# Canon SERVICE MANUAL REPORT

Serial No. AC10-016

Date 24th May, 1965

## REGARDING CHANGED IN CHECKING METHODS FOR SHUTTER RELEASES OF CANON FX AND PELLIX

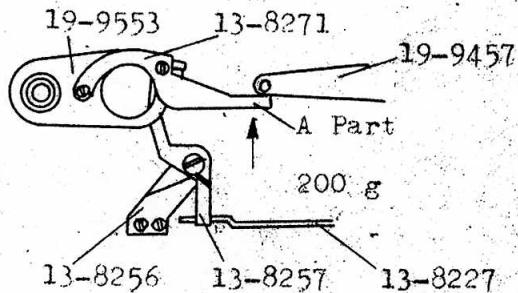
Recently there have been many claims that the shutter does not release even though the shutter button is pressed. The reason for this is that the mirror clamp lever (13-8257) does not get released. Heretofore, the release of the mirror clamp lever was judged good when the difference between how strong the mirror charge lever (19-9553) was set and the weight of the release of the mirror clamp lever was 40 g. However, due to fluctuations in measuring and instability in the checking method, we have changed the checking method as follows:

The mirror clamp lever (13-8257) should come loose when the shutter button is pressed while pressing the A part of mirror charge lever (13-8271) at 200 g with a tension gauge.
